*Re: Application of Dino and Michelle DeLaurentiis for Site Plan Approval for the
Construction of a Single-Family Residence and a Tree Removal Permit
To Permit Tree Removal in Connection with the Development of the Residence
Property: 21 Nethermont Ave. North Castle Tax Map Section 122.16, Block 4, Lot 41*

MEMORANDUM

SUBJECT: 21 Nethermont Ave

DATE: June 21, 2022

SD-1

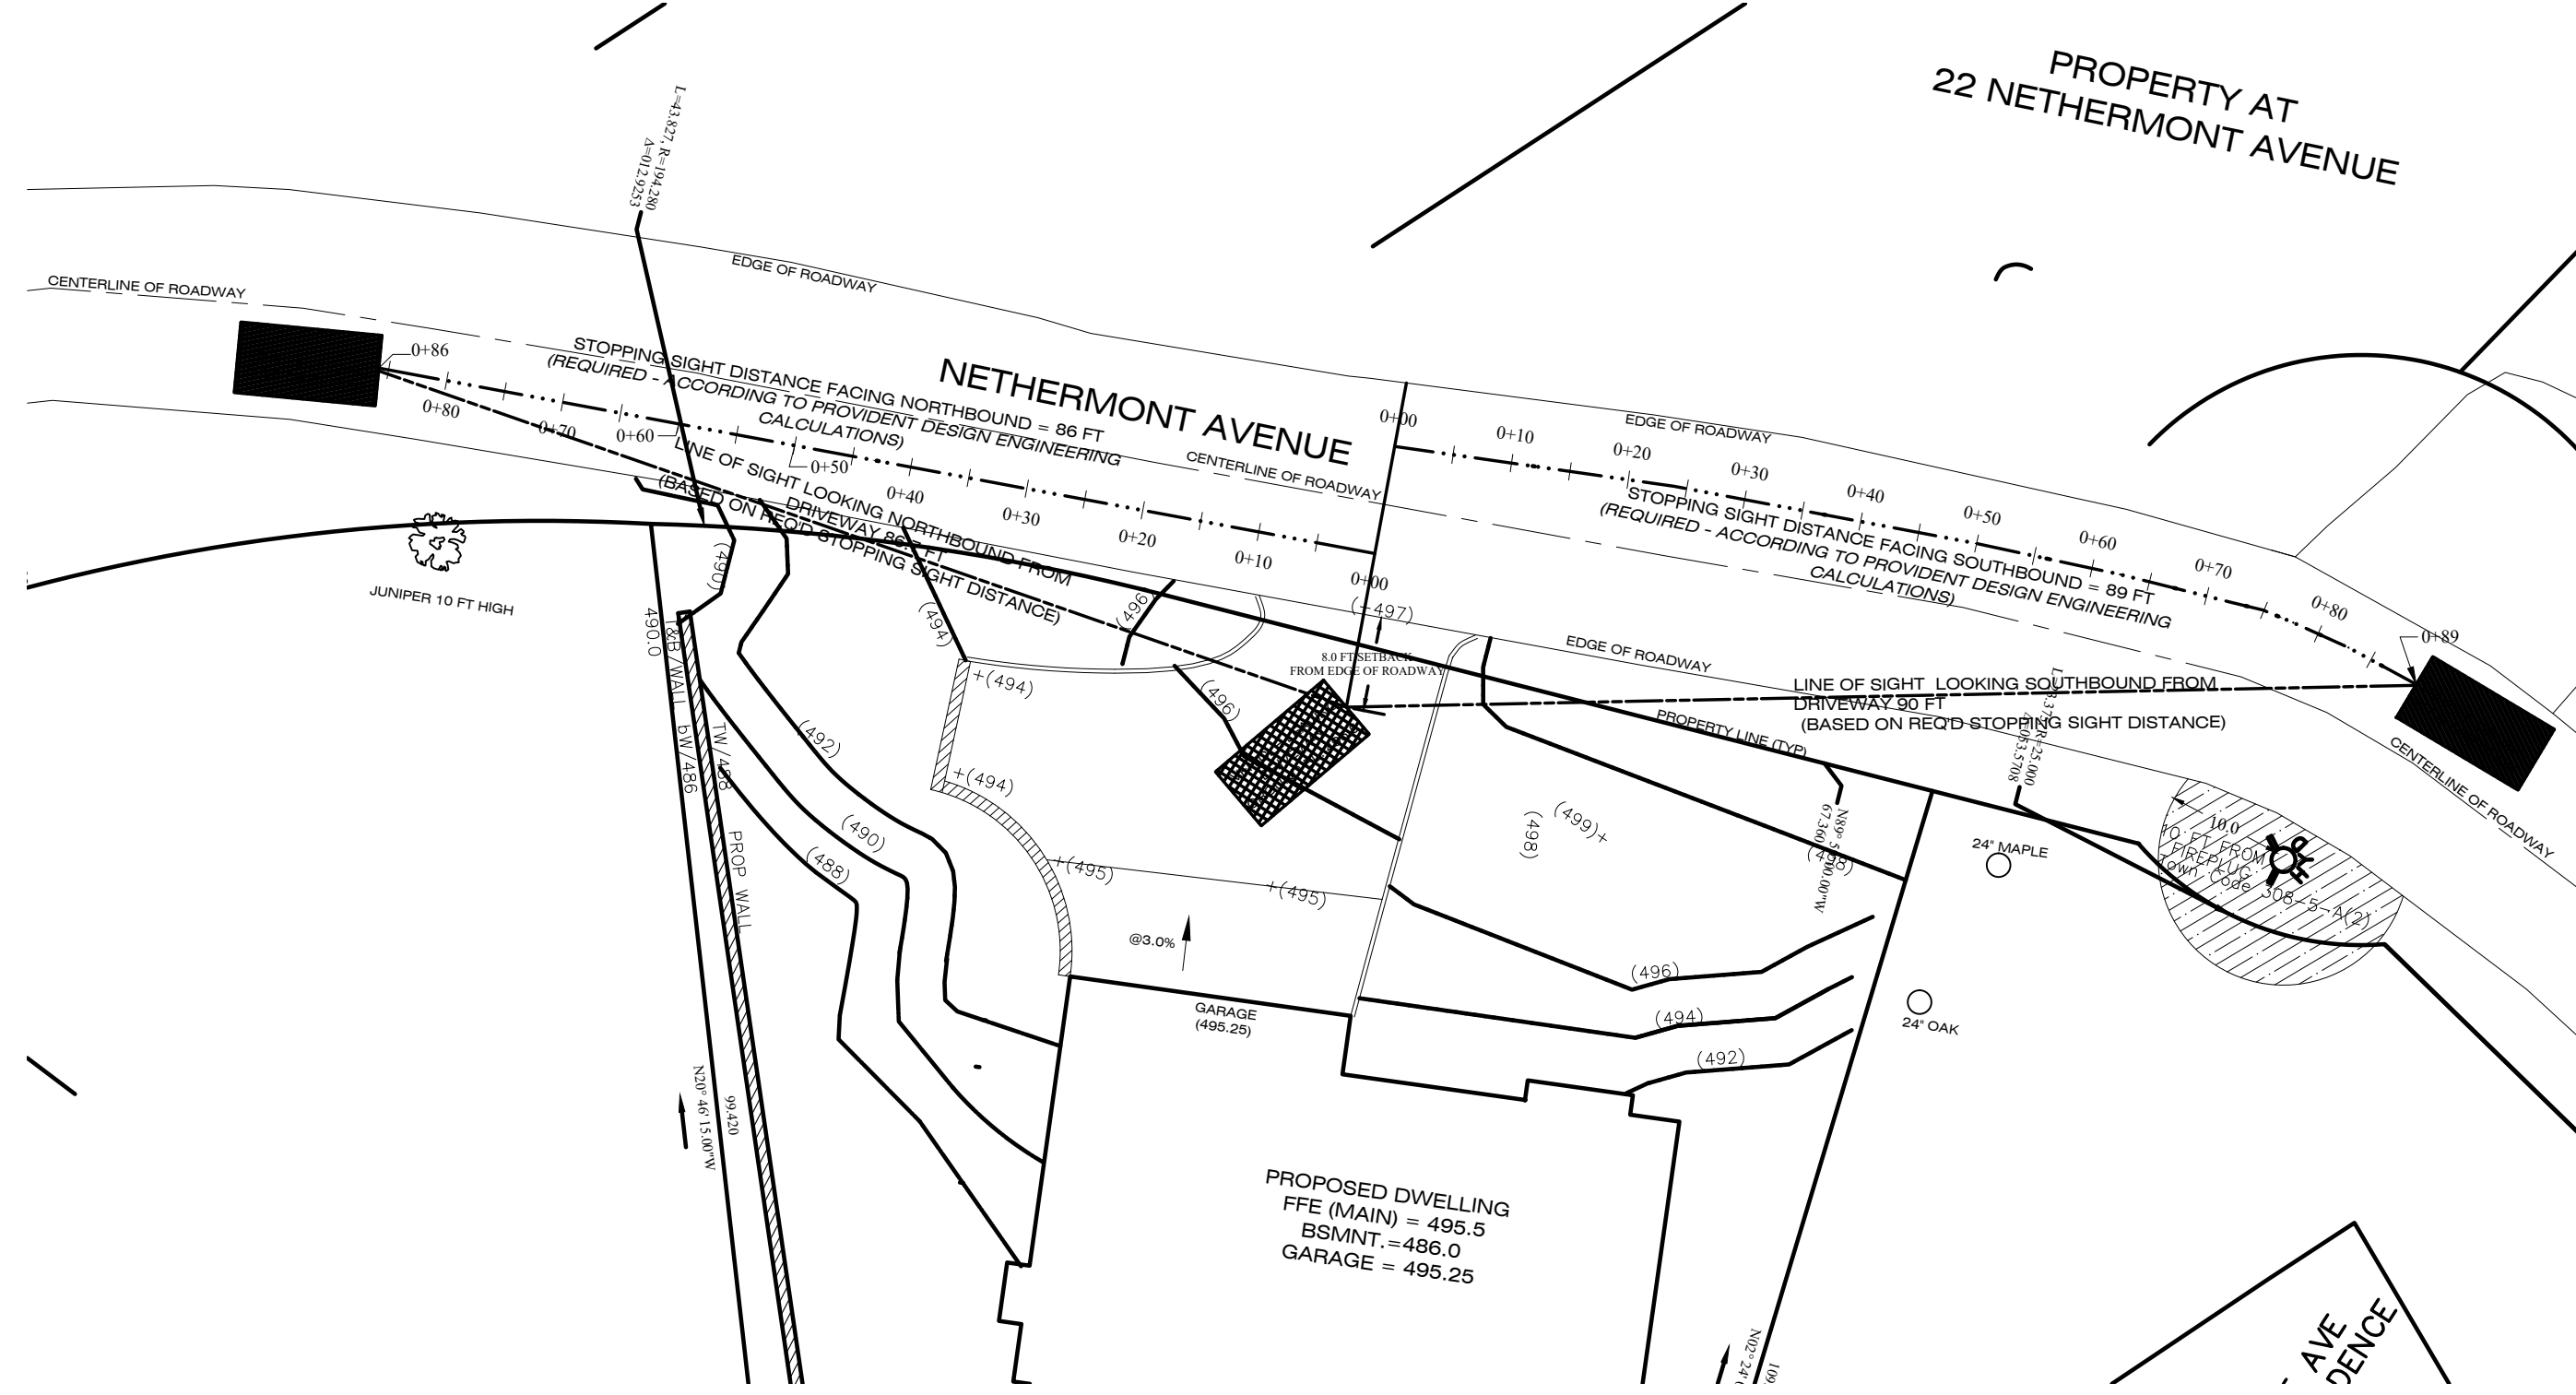
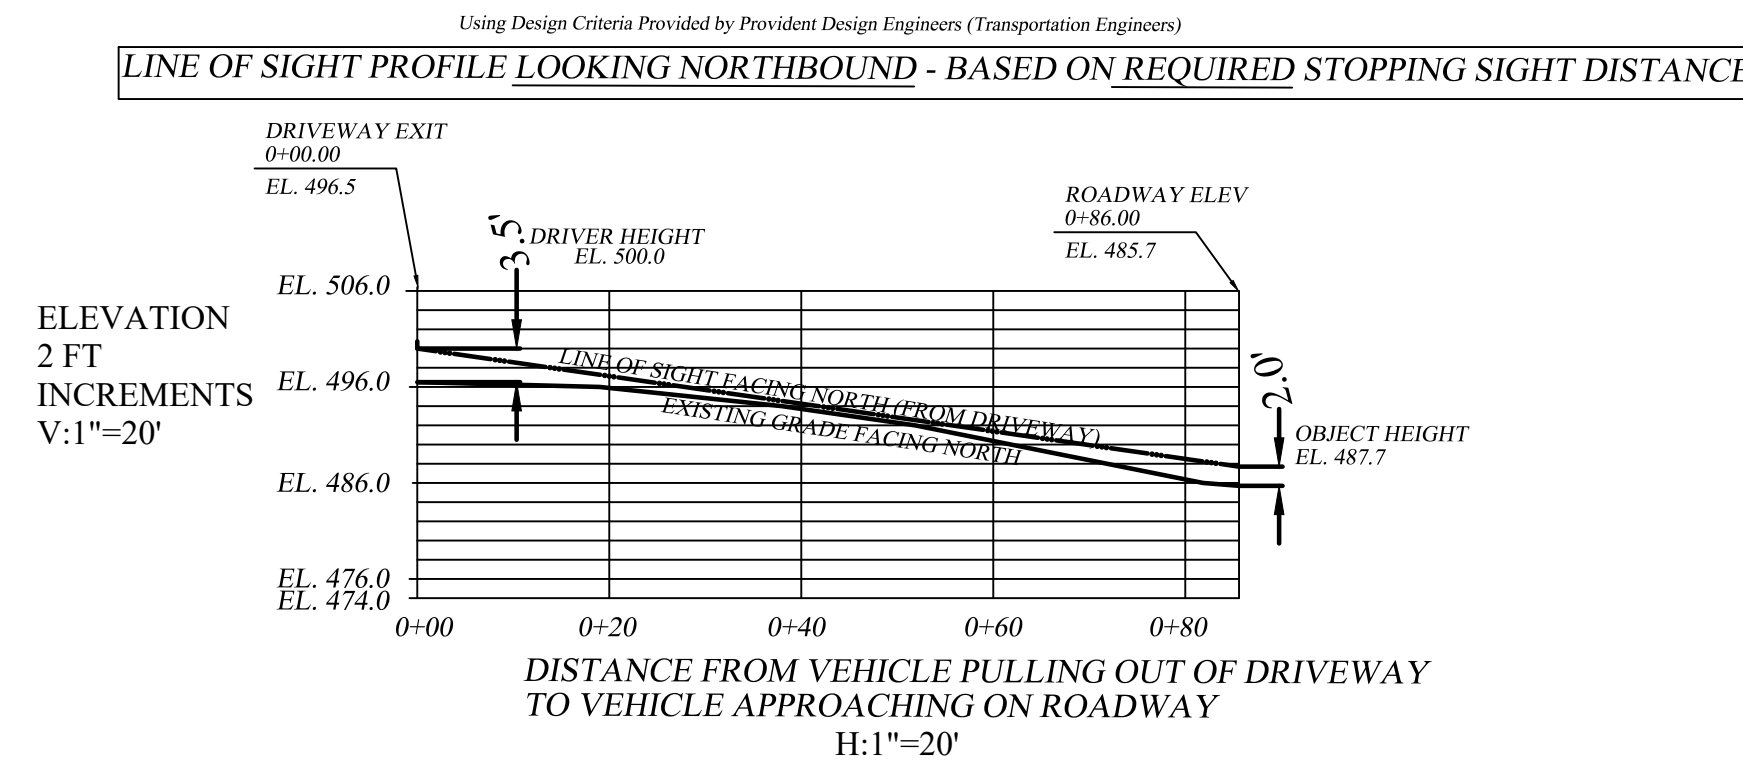
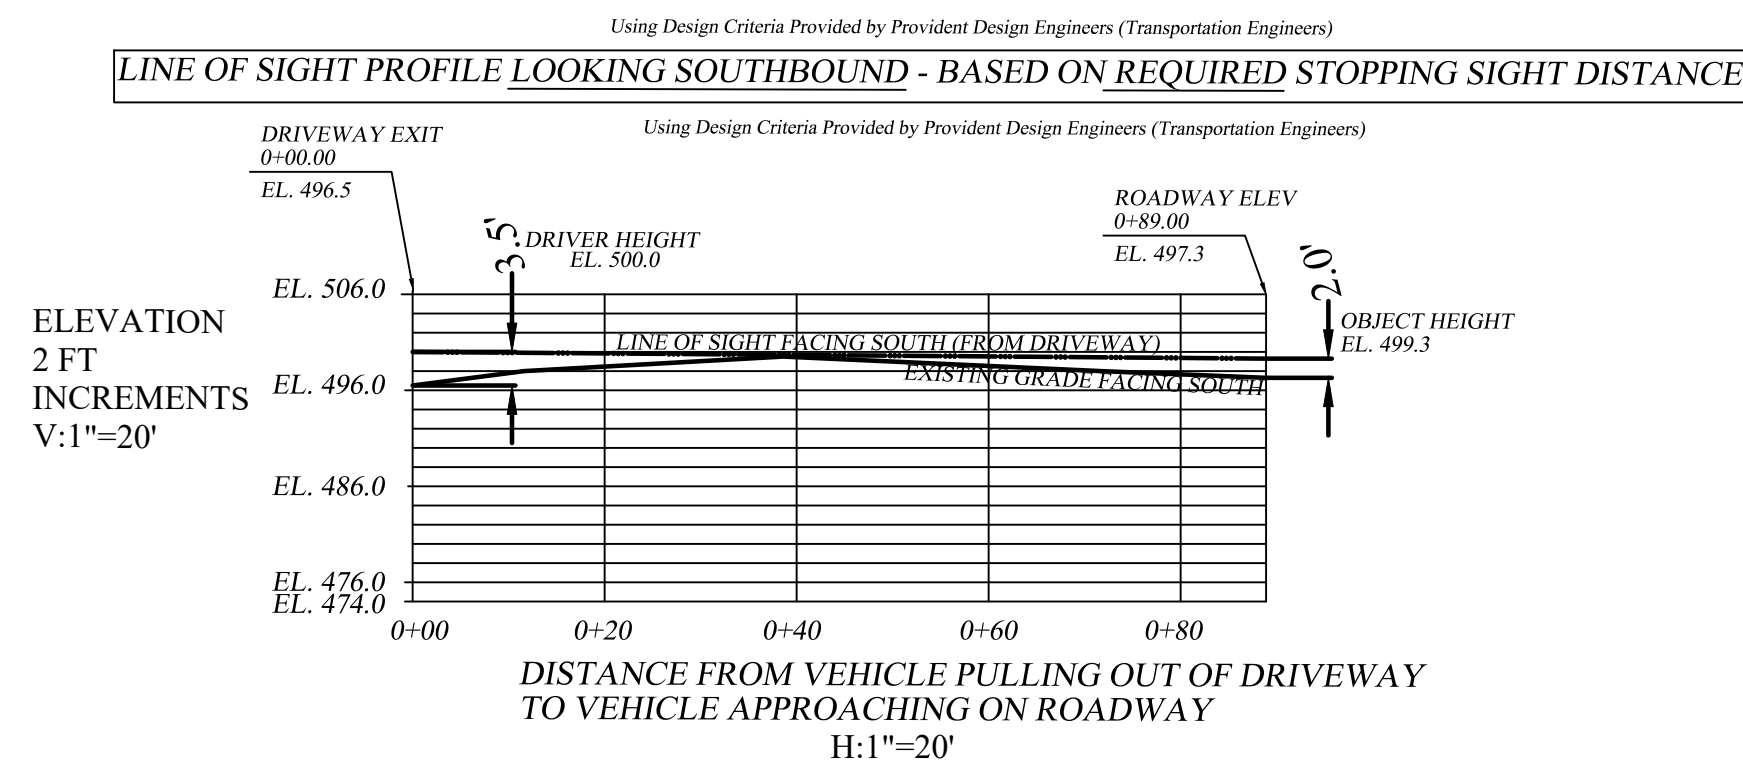
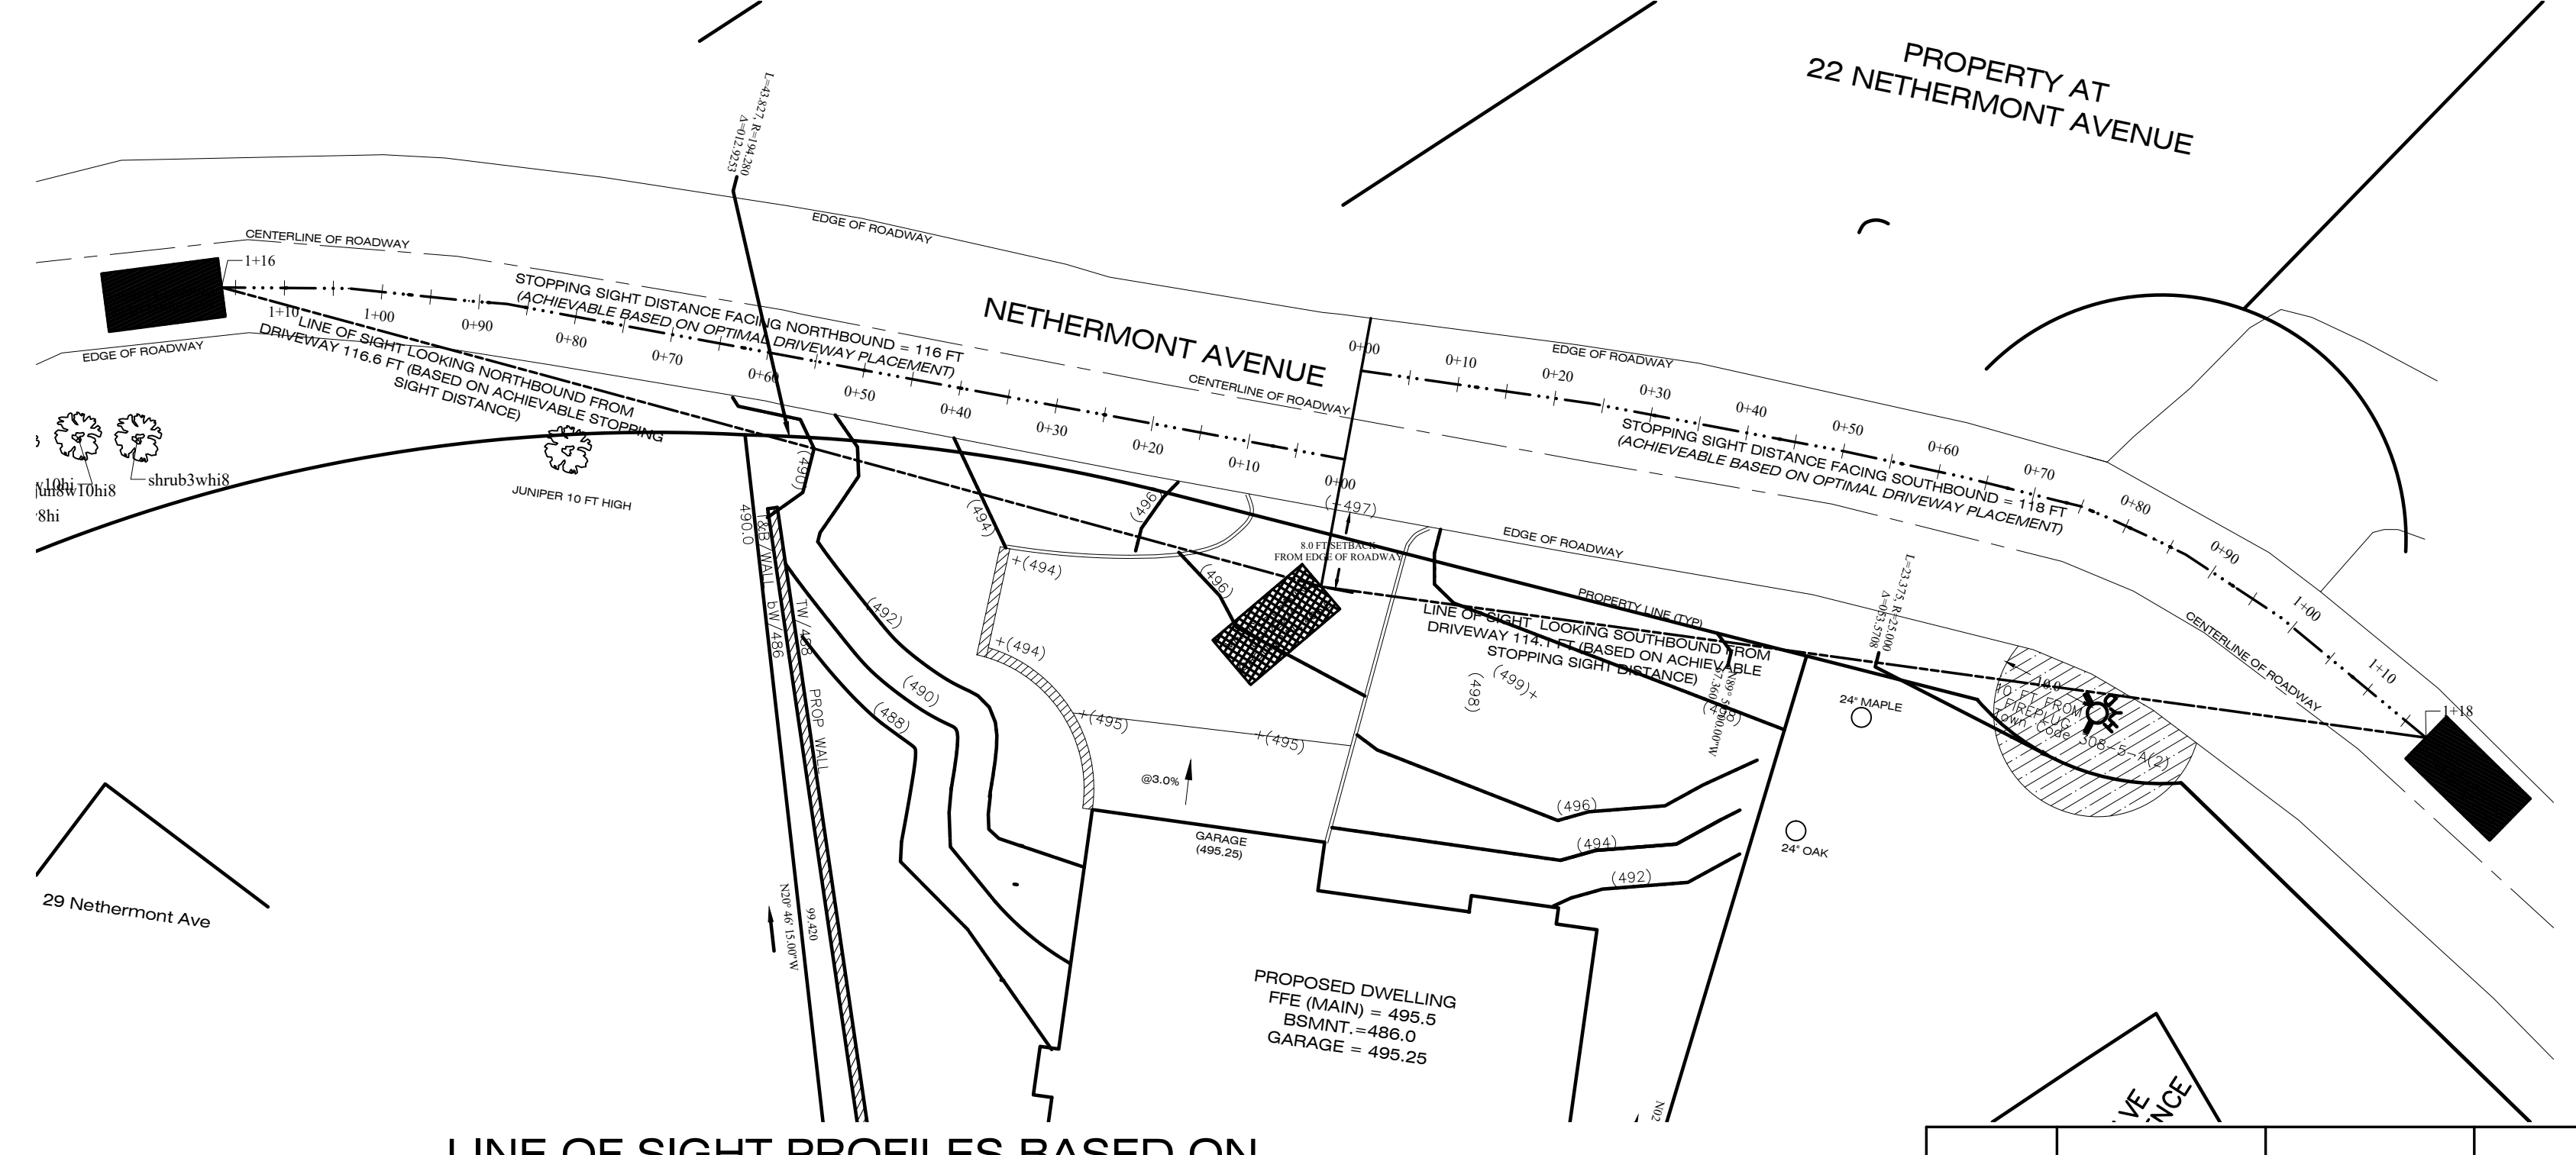
8. As previously requested, sight distance profiles have been provided, however, they shall be corrected to illustrate adequate sight distance for a minimum of 200 feet in each direction. It is difficult to verify compliance based on the imagery provided. We would suggest importing the GIS topography and planimetric data to generate the profile as opposed to working from an image. The sight profile shall establish the driver's eye set 3.5 feet above grade, 14 feet back from the edge of the road with a line of sight to an object in the road 2 feet above grade. The elevations shall use the same datum as the submitted plans and correspond to the grades in the profiles.

The sight analysis plans for either the original or alternative driveway access do not illustrate all information necessary to properly evaluate the alternatives. The topography used for the analysis does

not correspond to the proposed grading plan. It seems that rather than convert the Westchester County GIS data to the plan topography, the opposite was done. This should be corrected for consistency and coordination with the proposed plan. Neither alternative illustrates the dense vegetation that exists along the northern property line, much of which is on the adjoining property and not und

er the applicant's control. The alternative driveway plan notes that the sight lines are obscured to the north due to a minor conflict with the proposed driveway turnaround. It appears that this could be rectified as part of the proposed grading plan. Finally, both alternatives will require sight easements across the front yards of both neighboring properties. The applicant should update the Board regarding any conversations they may have had with the property owners, as well as any communication with the Town Highway Department regarding any required clearing in the Town right-of-way. If the minimum required sight distance cannot be obtained, the plan should illustrate the minimum that can be provided as an area variance would be required from the Zoning Board of Appeals.

A Zoning Variance was obtained for the sight distance.
